INSTALLATION INSTRUCTIONS DODGE RETROFIT PITMAN ARM KIT

**2003-2008 Dodge 2500 /3500 4x4 All Models & 2006-2008 1500 4x4 Mega Cab.
FTS93001R Retrofit Pitman Arm Kit**

Fabtech Pitman Arm Exchange Processing Instructions

Part- FT44039 Pitman Arm included in FTS23006, FTS23006BK, FTS23017BK and FTS93001

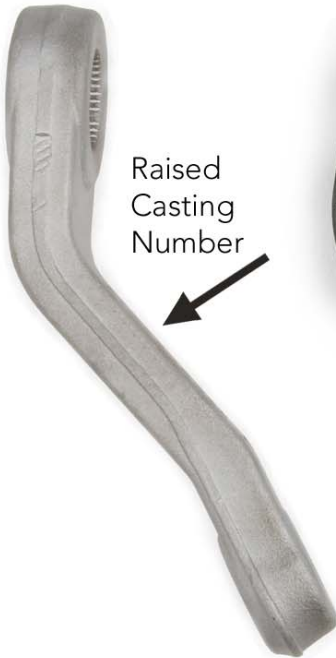
Initially a visual inspection should be performed by locating the Pitman Arm and identifying the part as shown below. Should a Fabtech Pitman Arm without the raised casting number on the Arm be present, the vehicle should immediately be processed by a Fabtech Authorized Installer. A Pitman Arm that has a raised casting number does not need to be replaced and does not qualify for this program. Only Fabtech Pitman Arms without the raised casting number qualify.

Recall Arm

Does not have raised casting numbers on Arm. Must be exchanged.

Once the vehicle is at an Authorized Installer the Fabtech Pitman Arm must be removed immediately and be replaced with a provided Fabtech raised casting numbered Pitman Arm. This Pitman Arm exchange must be performed per the provided Fabtech installation instruction.
